MONITORING YEAR 0 ANNUAL REPORT

CROSS CREEK RANCH SITE

DMS Project No. 100138
NCDEQ Contract No. 7879-01
DMS RFP No. 16-007879 / Issued: May 6, 2019
USACE Action ID No. 2020-00051
DWR Project No. 2020-0016
Data Collection Dates: February 2022 – July 2022

Subject: DRAFT MY0/As-Built Baseline Report & Record Drawings Review
Cross Creek Ranch Site
Yadkin River Basin – CU# 03040104
Montgomery County
DMS Project ID No. 100138
Contract #. 7879-01

Figure 1. Current Condition Plan View
 Cross Creek Ranch Site
 DMS Project No. 100138
 Monitoring Year 0 - 2022
 Montgomery County, NC

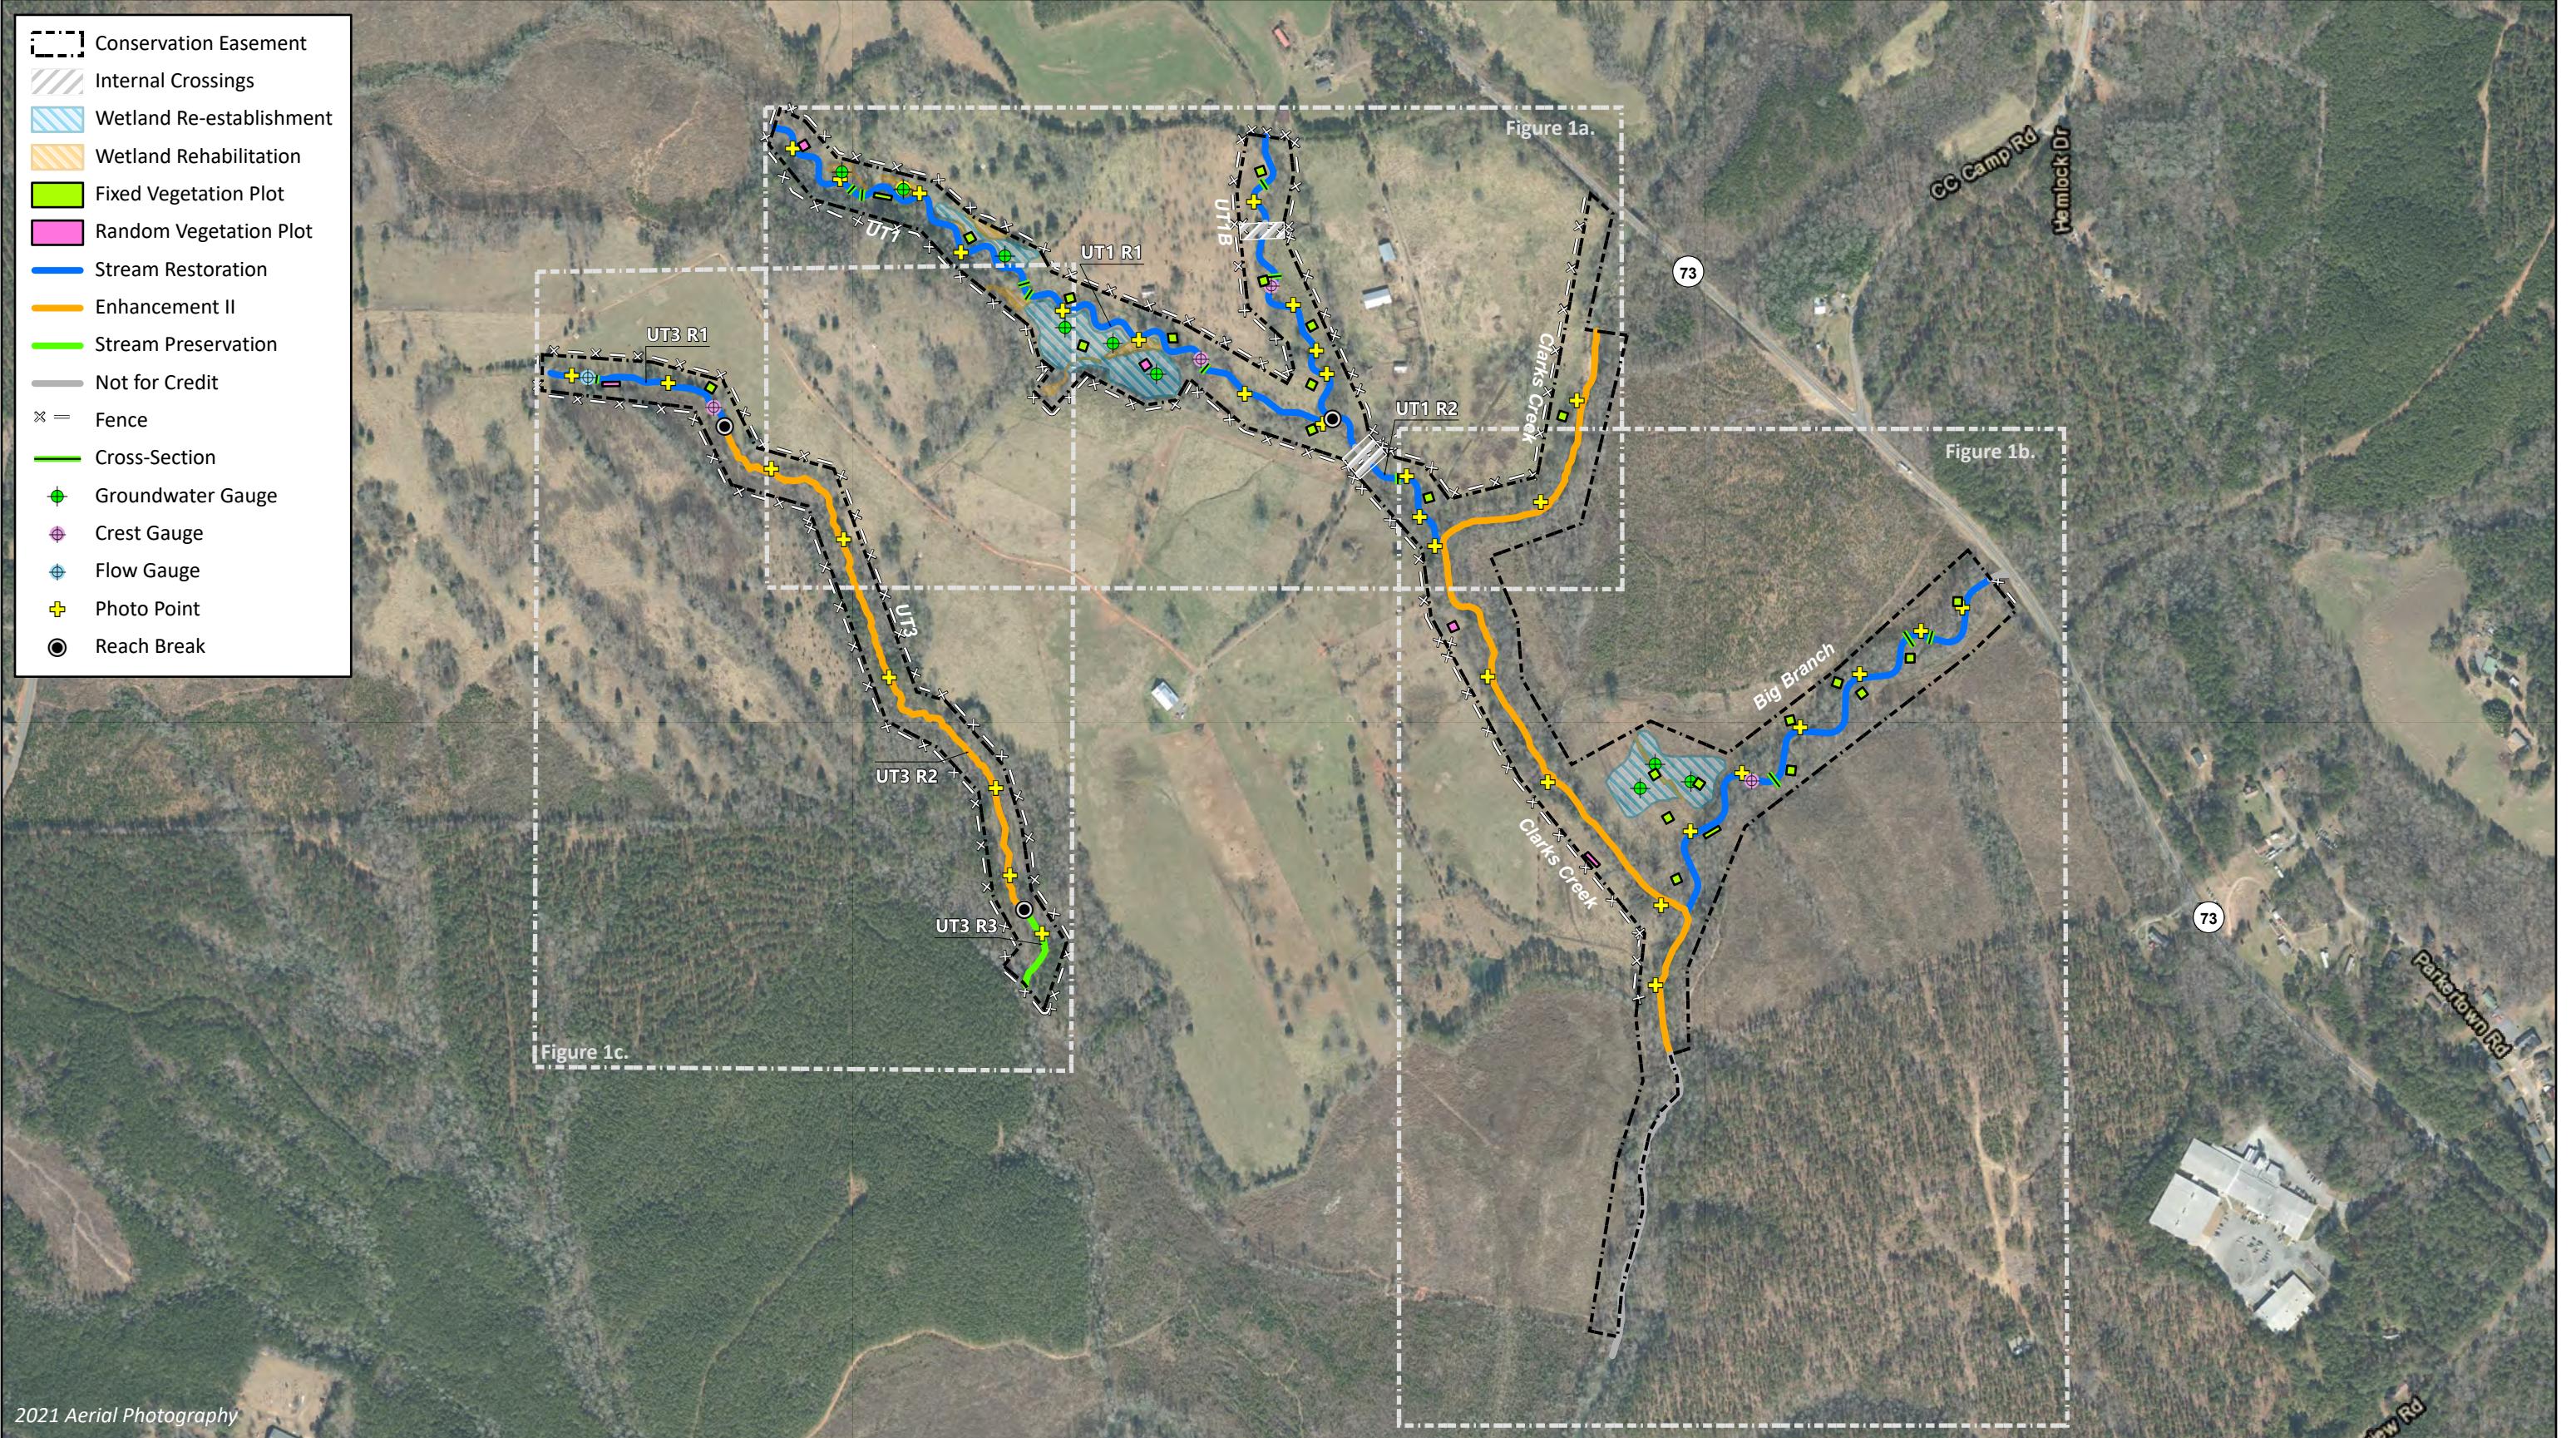
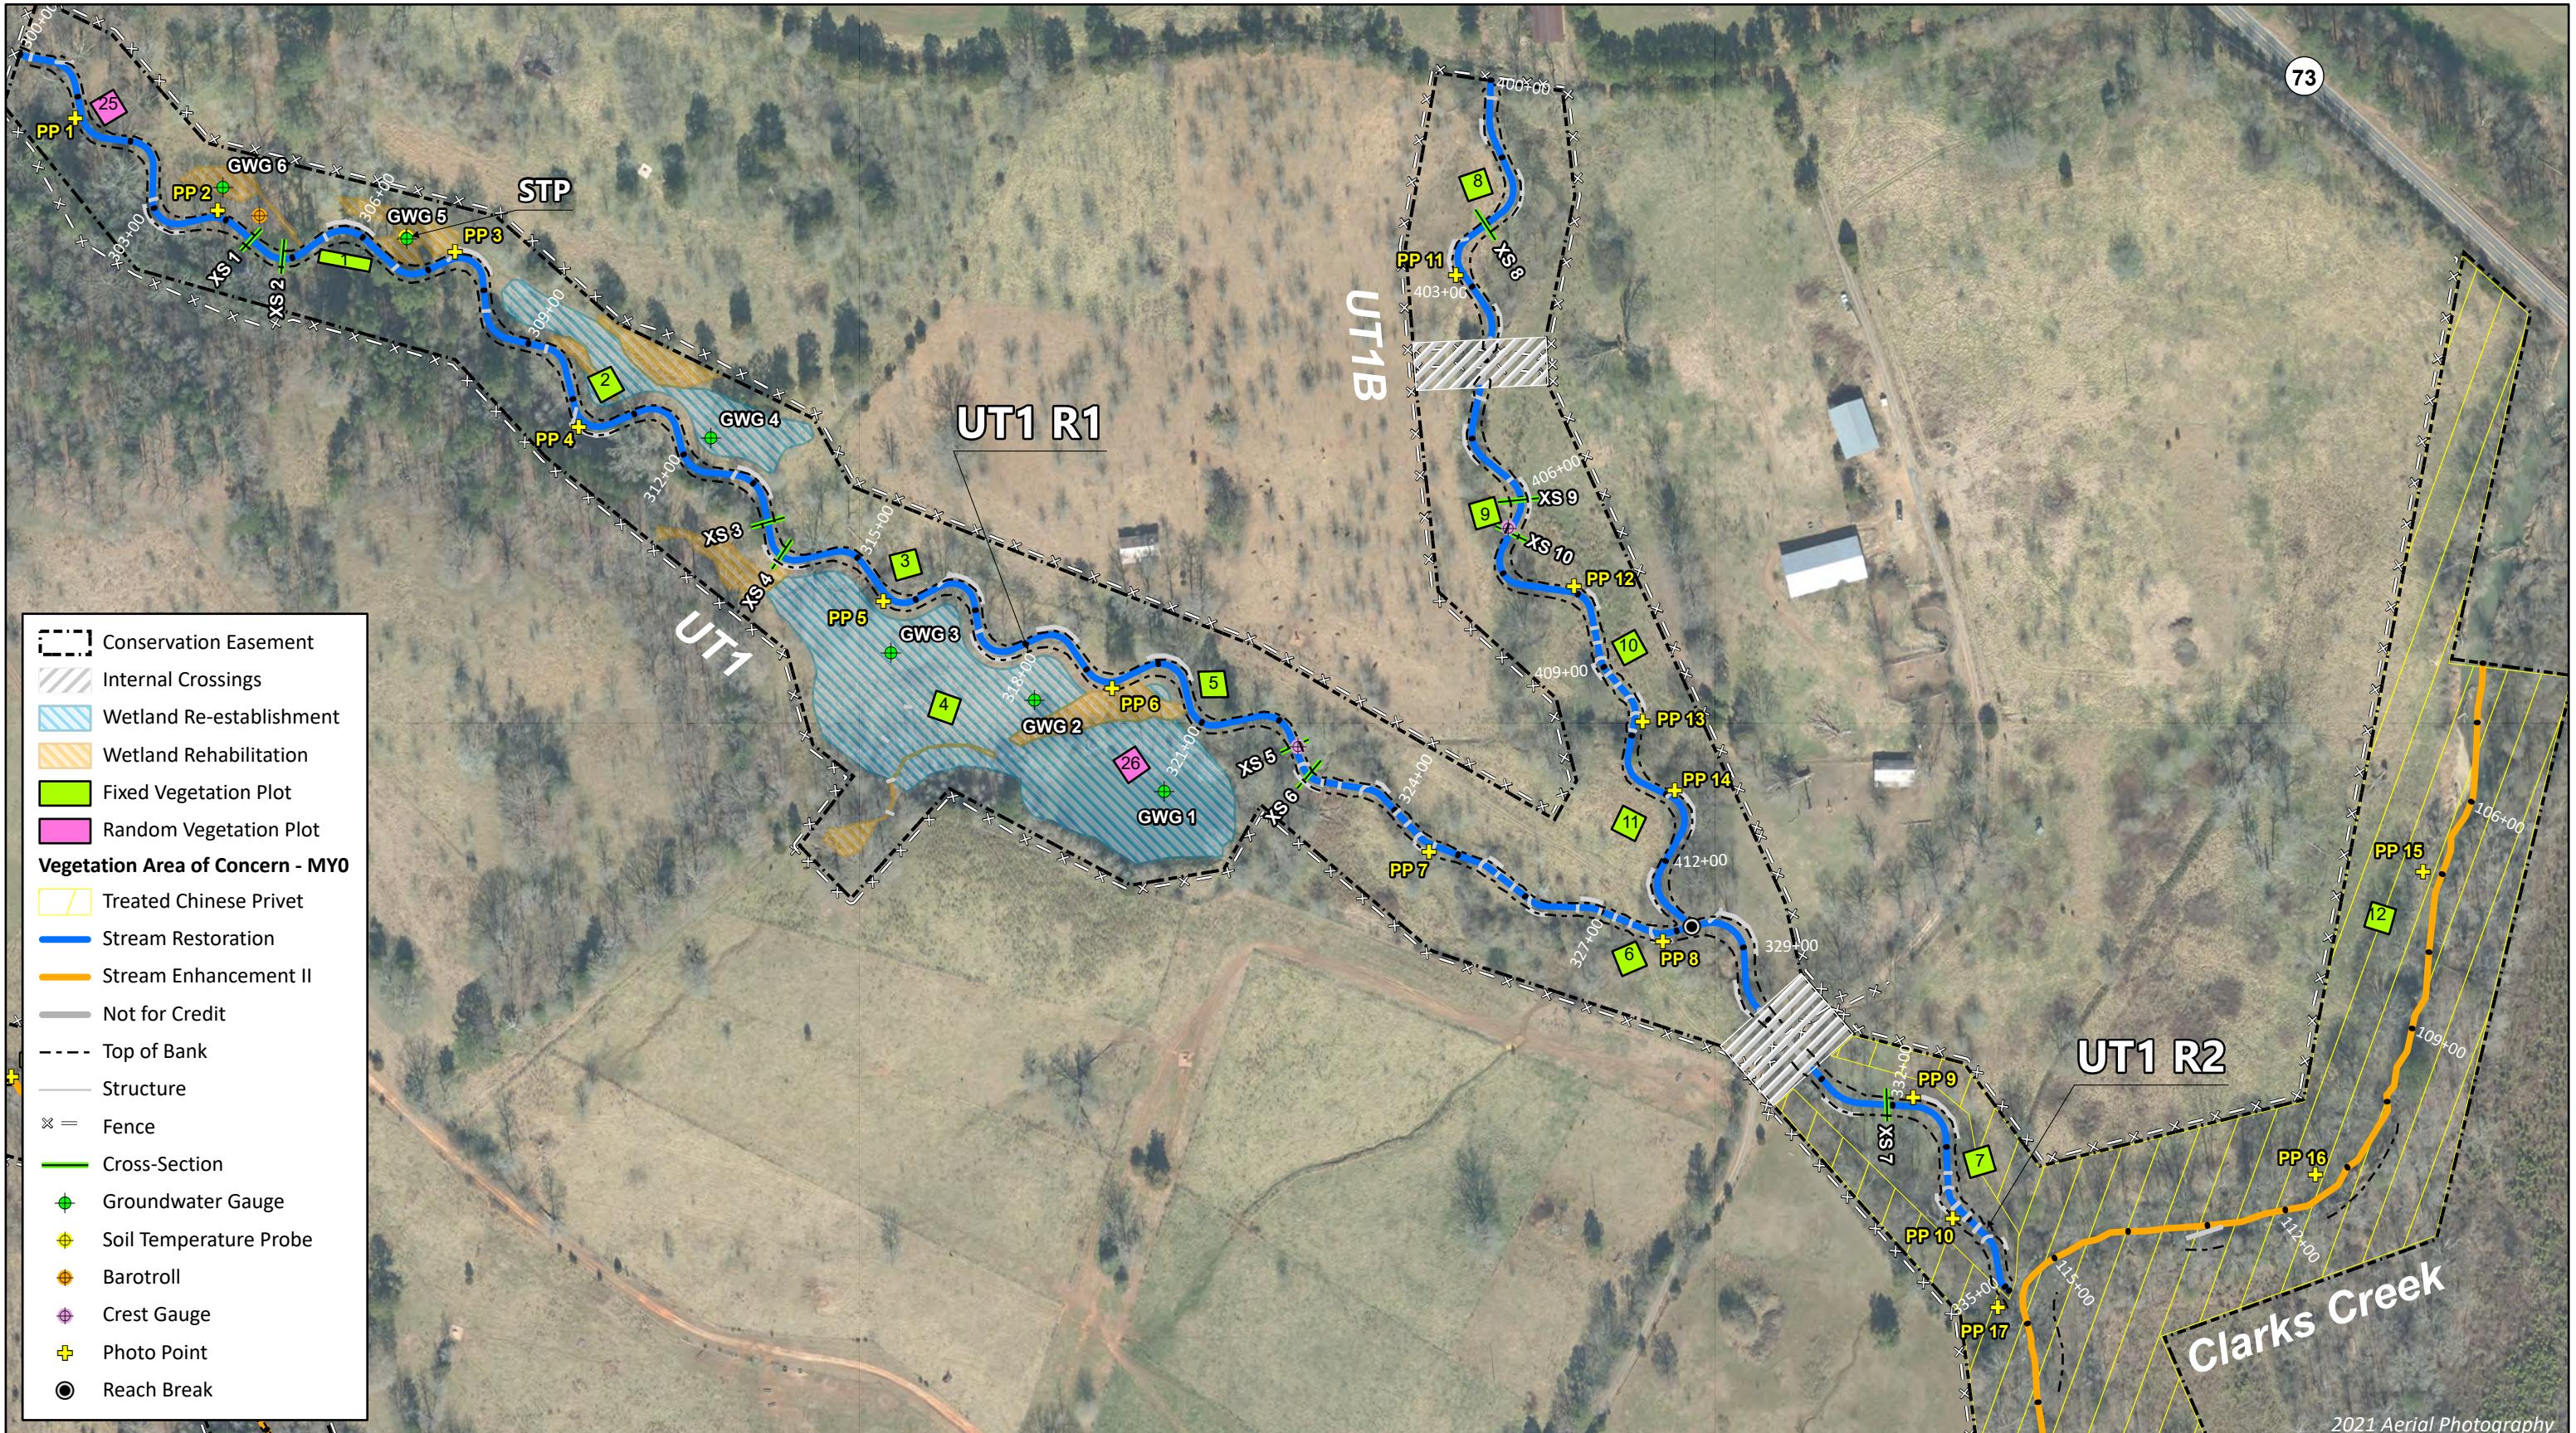
Figure 1 and Figure 1B - CCPV: Add the internal crossing shown on Sheet 1.2.1 of the Record Drawings to the figure.

Response: Sheet 1.2.1 of the Record Drawings mislabeled the utility easement, which is outside of the conservation easement, as an internal crossing. There is no internal or external crossing along Big Branch, therefore the CCPV does not show one. Sheet 1.2.1 has now been updated to accurately reflect the utility easement.
